ADDENDUM NO.2

DATE: May 31, 2019
PROJECT: Paragould Fire Station #1
Paragould, Greene County, Arkansas
ETC Project No.: 15032CPARA

18 OIL WATER SEPARATOR
N.T.S.

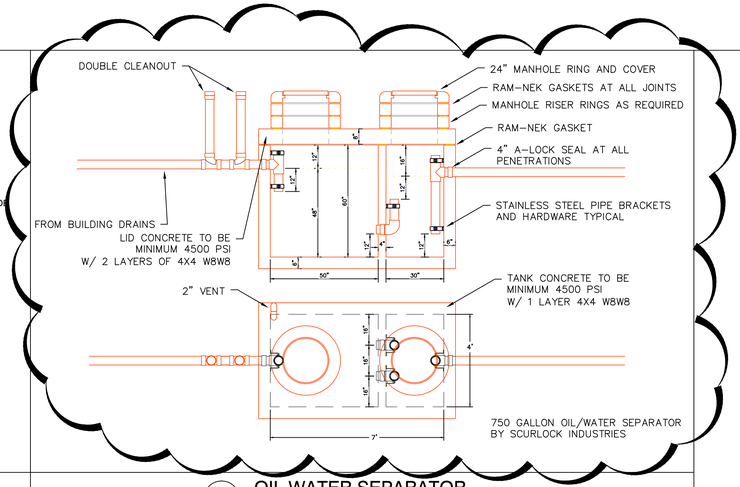
1. Please see attached revised drawing sheet D3. This drawing includes a change to the oil/water separator.

DATA PLAN

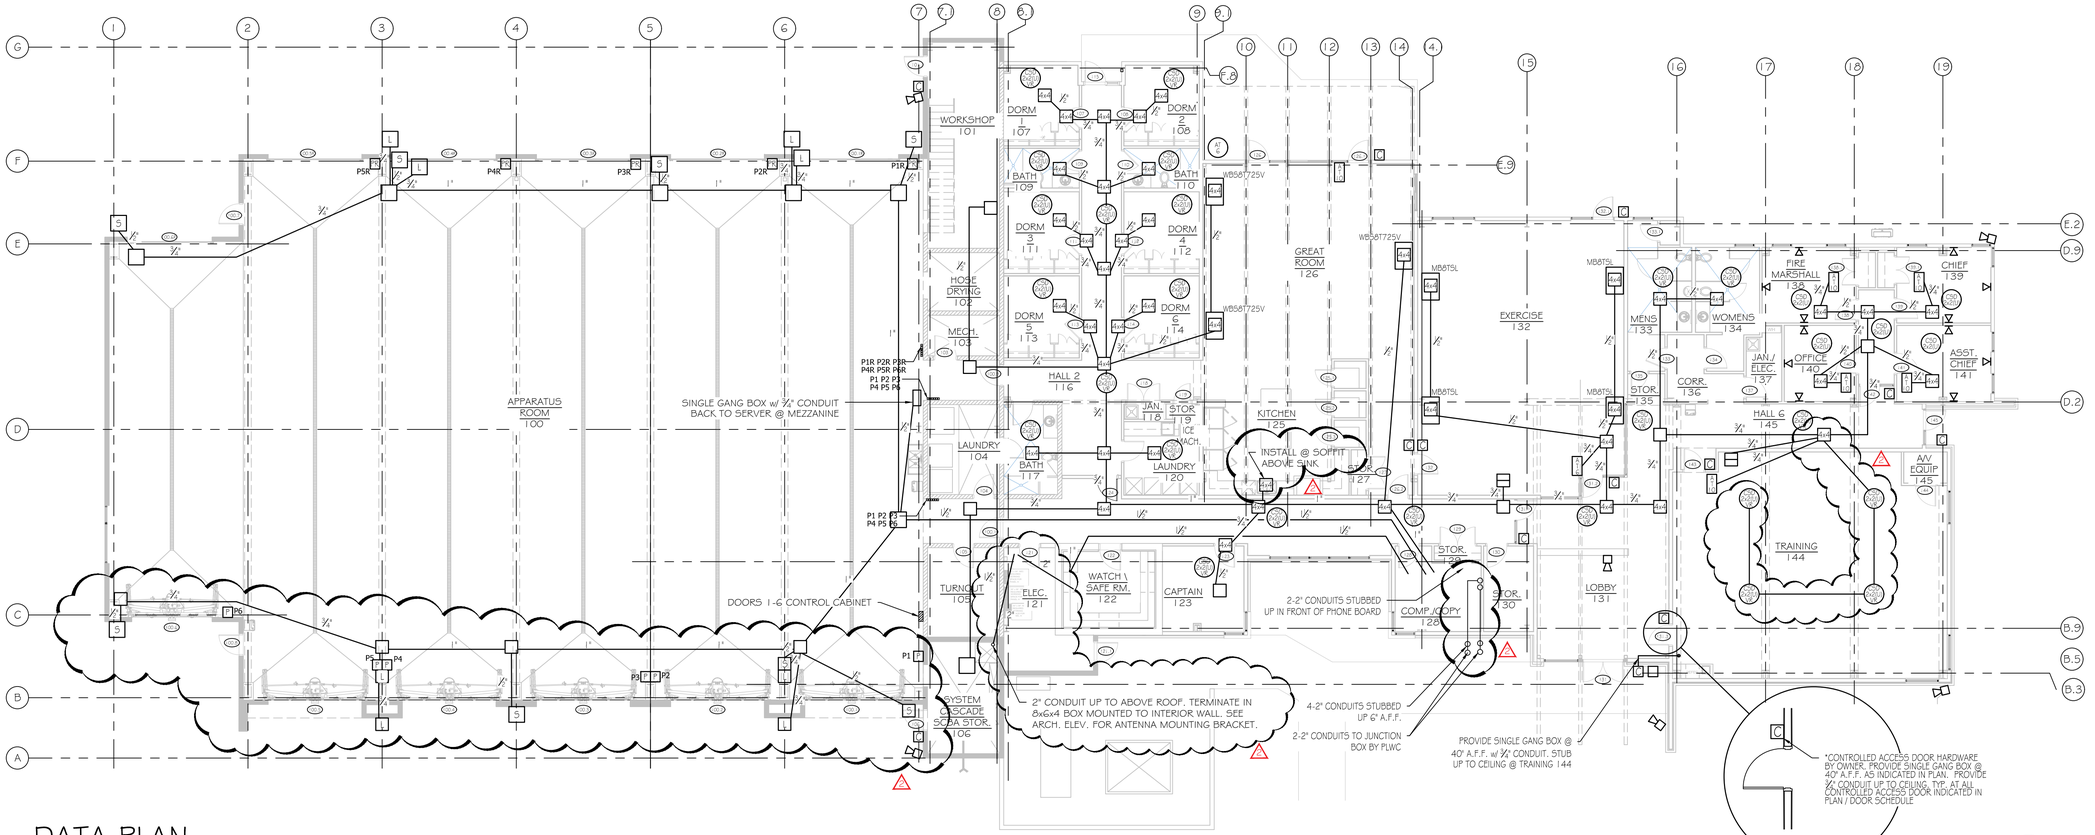
1. Revised for clarity.

S1.5 | S1.6 TYPICAL SECTION ALONG MEZZANINE FRAMING

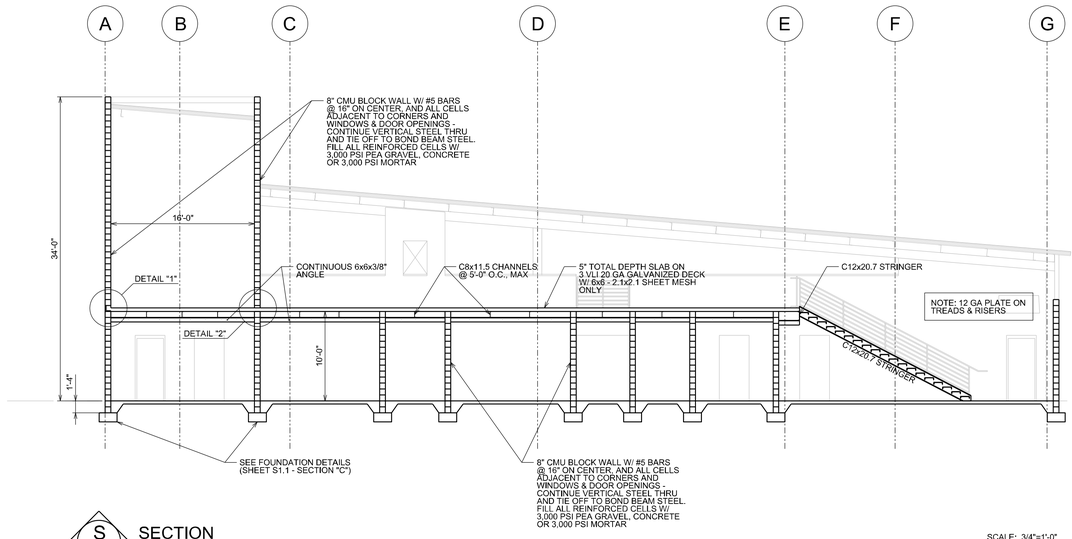
1. Added Mezzanine Framing

SURVEY BY:
DESIGN BY: WRA
DRAWN BY: WRA
CHECKED BY: WRA
DATE: MAY 6, 2019
JOB NO: 150302CPARA
FILENAME:
SHEET: R1.1

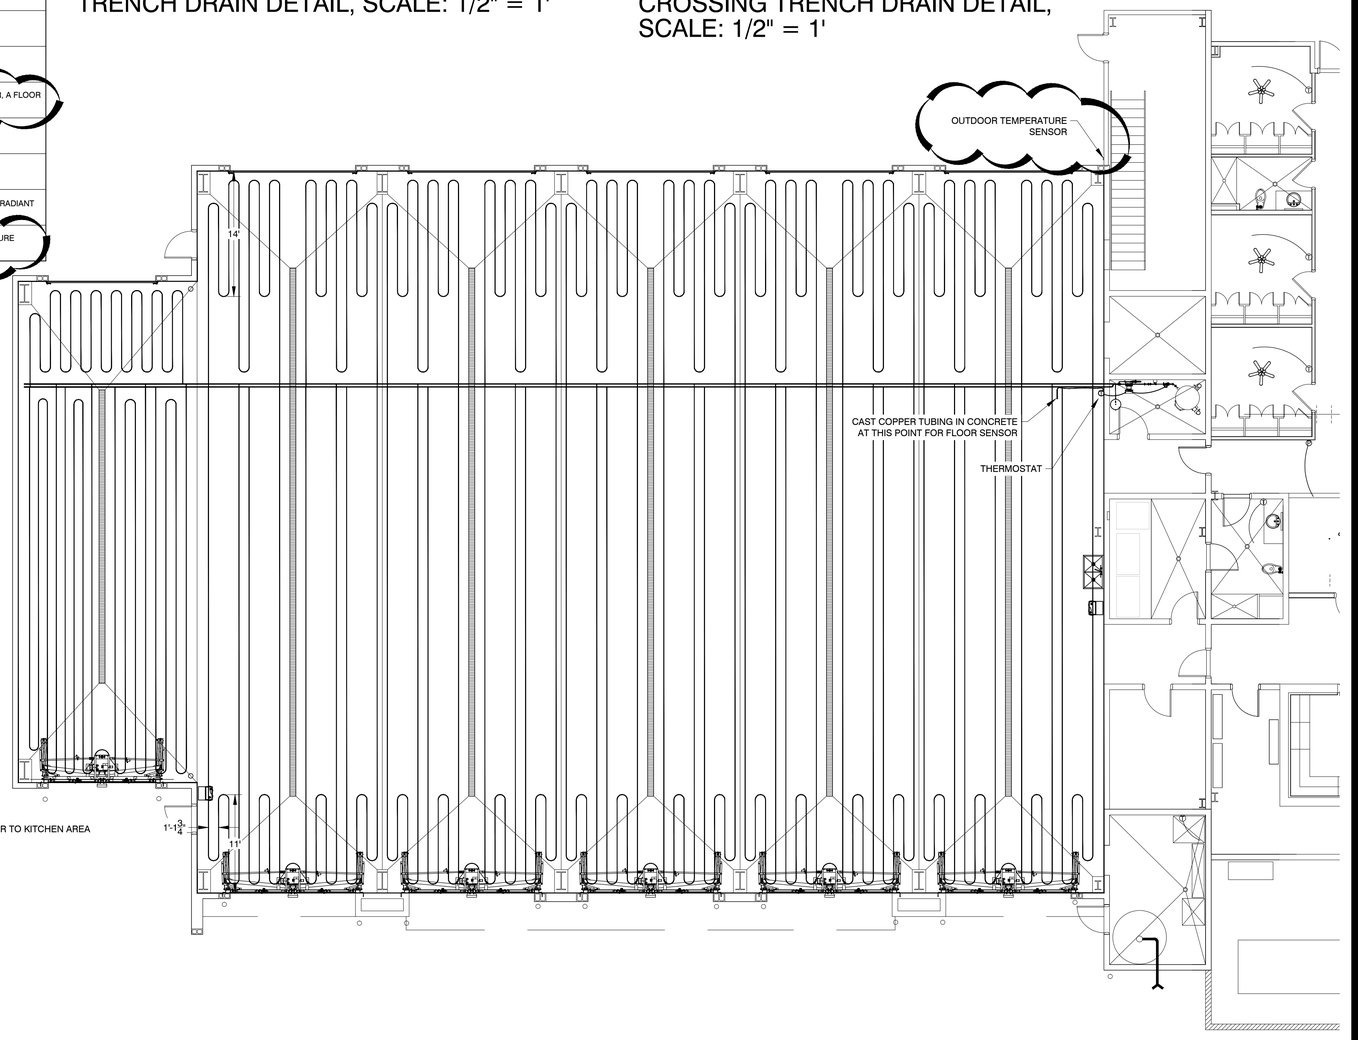
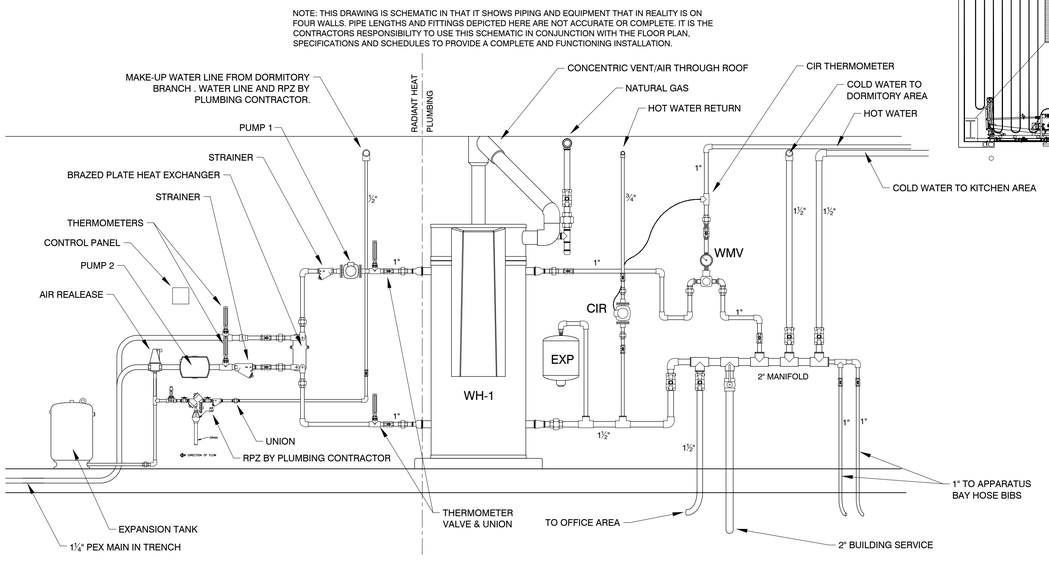
1. Please refer to the Radiant Floor System table on sheet R1.1 and the included revised sheet R1.1

2. Pump 1 to change to: Taco "00" Series 009-IFC Stainless Steel variable speed accepting a 0-10V analog signal.

3. Delete the Aube/Honeywell thermostat. Replace with Tekmar House Control 402 and Tekmar thermostat with tekmarNet 2. Variable speed pump 1 is to be controlled by the 402 to maintain loop temperature by a "mix sensor" installed in a thermowell just downstream of the plate heat exchanger. The House Control 402 will have a mix temperature sensor and an outside temperature sensor. The thermostat shall have a room temperature sensor and a slab temperature sensor. Provide the required transformers, conduits and wiring for a complete installation. As in Note 2, it is still acceptable to submit an alternate system.

The secondary fluid shall be a 50% Glycol mix.

OVERALL KEY FLOOR PLAN

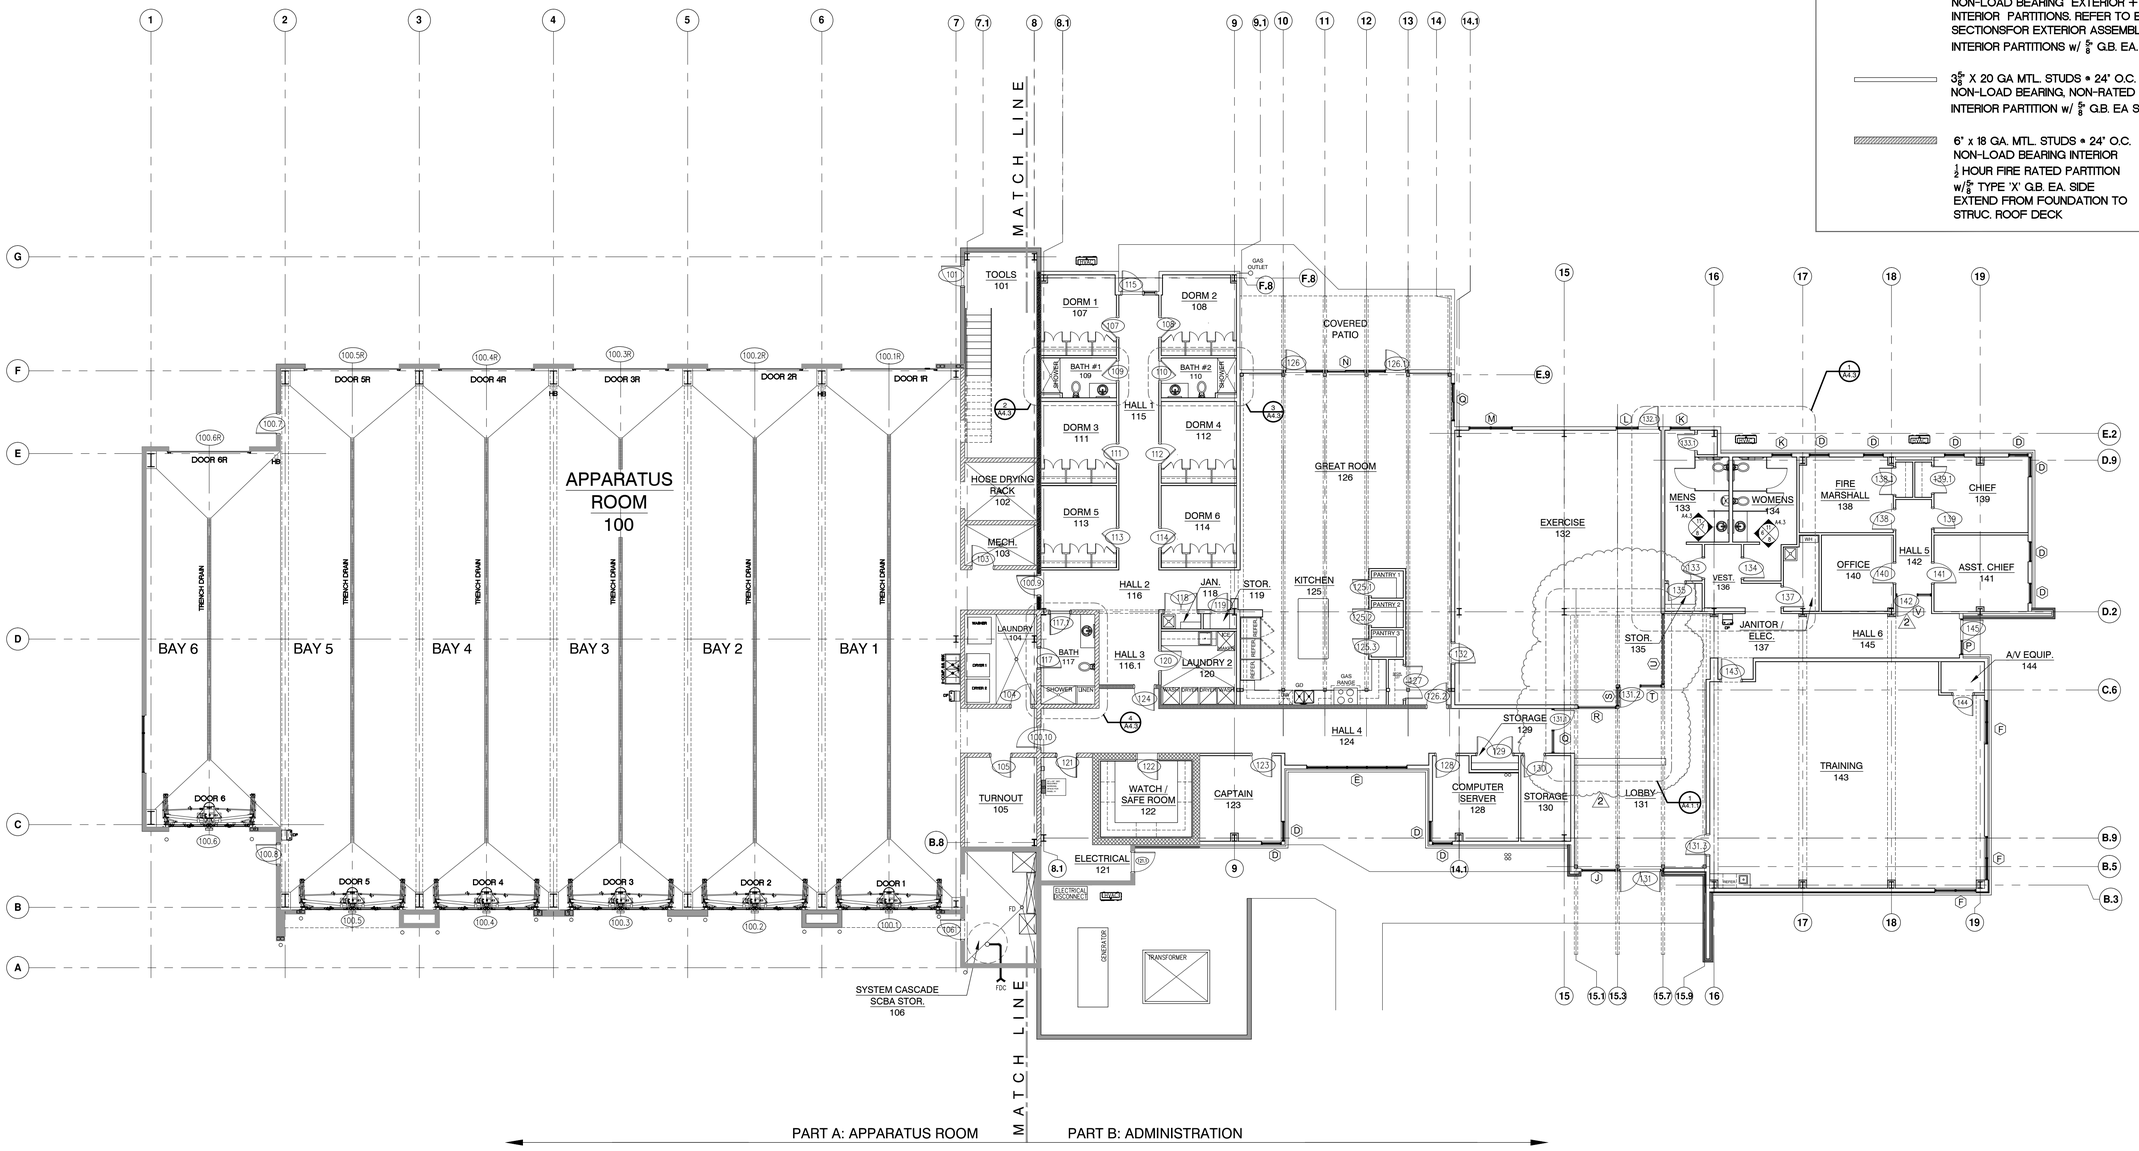
1. Added Window Tags at Lobby/Exercise

2. Added Window Tag for glass door/window unit @ Hall 5

3. Added Tag for Enlarged Plan at Lobby / Exercise

WINDOW TYPES
3/8" = 1'-0"

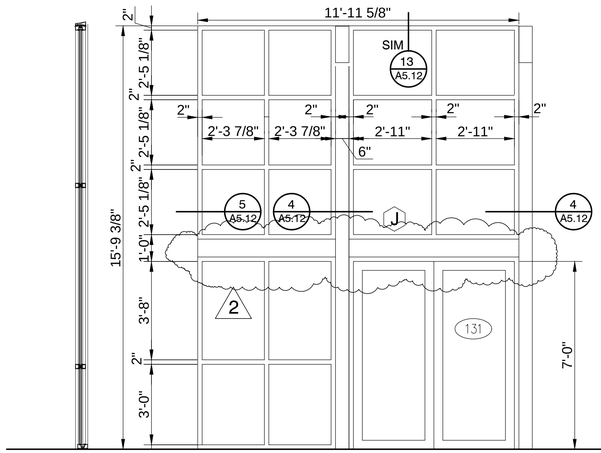
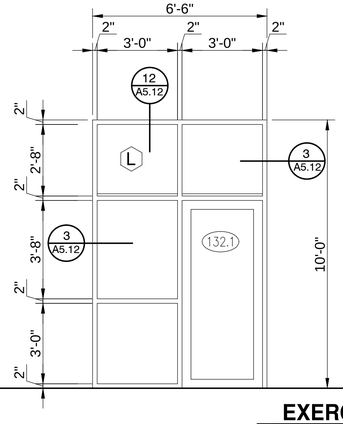
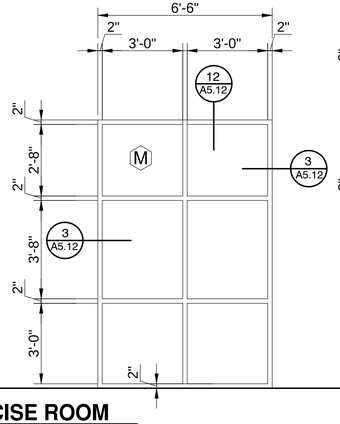
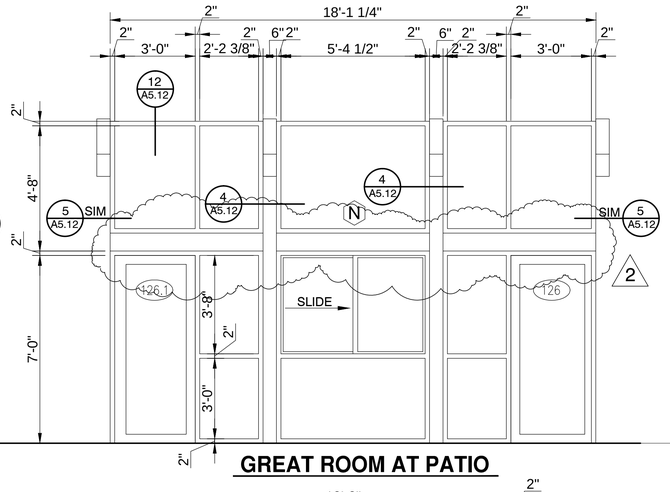
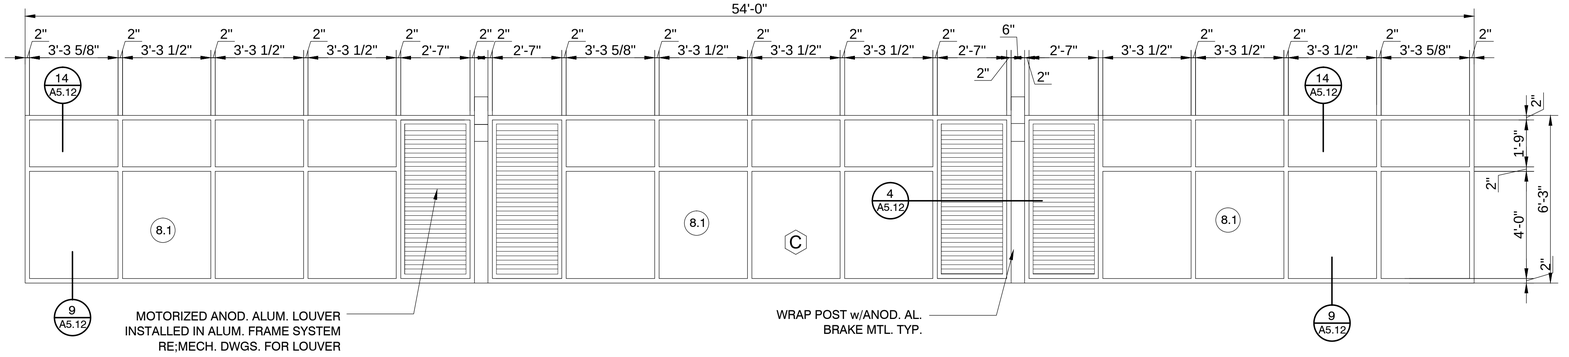
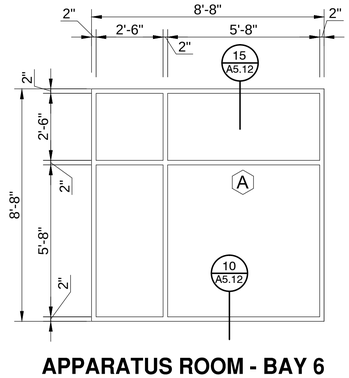
1. Revised Window Types J and N

1 KITCHEN - EAST INTERIOR ELEVATION

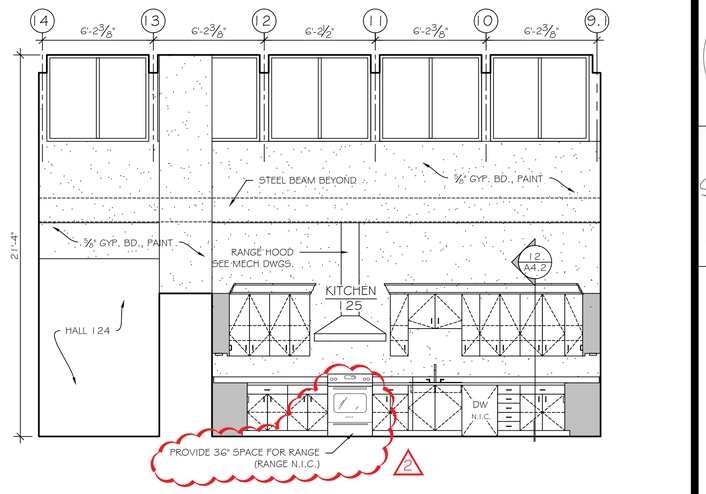
1. Revised Detail 1

2 GREAT ROOM / KITCHEN - EAST INTERIOR ELEVATION

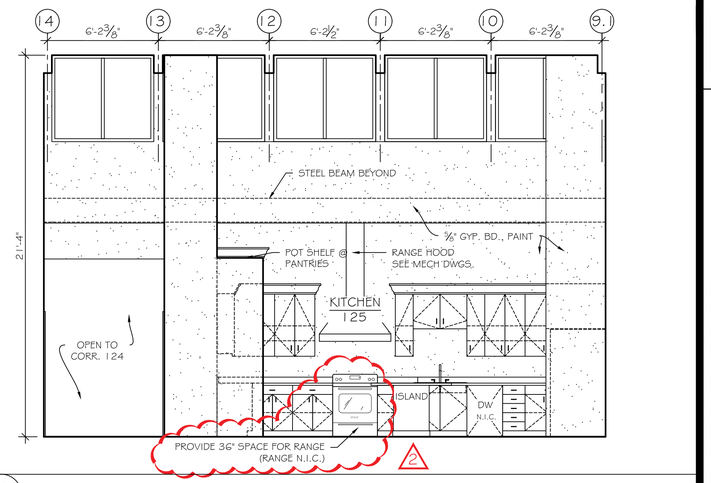
2. Revised Detail 2

3 GREAT ROOM - WEST INTERIOR ELEVATION

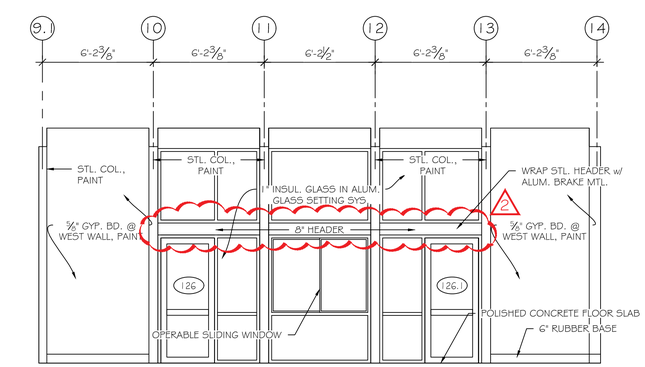
3. revised Detail 3
